Response to Reviewers

Earth Syst. Sci. Data Discuss.,
<https://doi.org/10.5194/essd-2019-206-RC1>, 2019

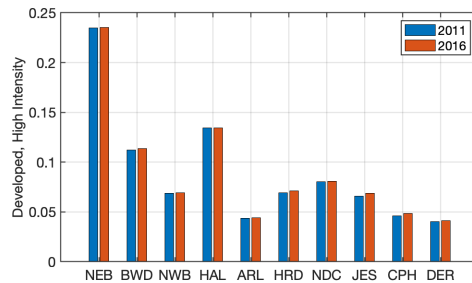
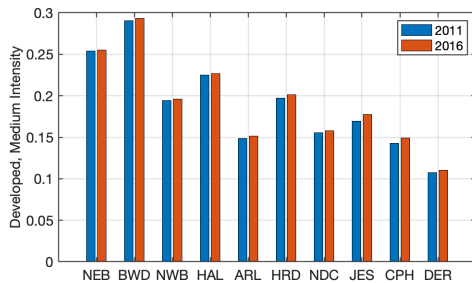
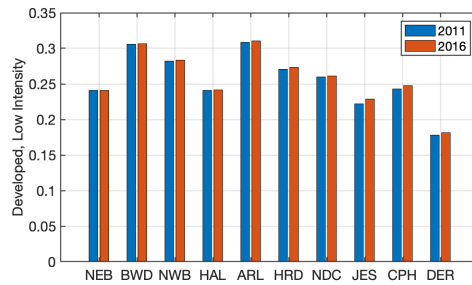
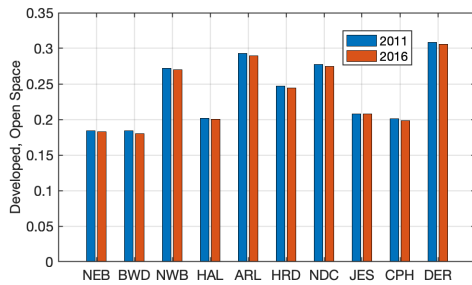
The intensity in development is used from the 2011 database. Has there been an evaluation of the trend in the intensity since 2011? Can those changes have an impact on the stations’ representativeness?

Thank you for this comment. We have updated Figs 2& 3 now using the 2016 NLCD database and found little to no difference between the two years. See the figure below, indicating the fraction for the 4 developed categories for the sites in figure 2 between the two products. The regional sites do not change very much either. We have updated the paper figures to use the 2016 database, as that is indeed more applicable to our data which covers 2015-2018.
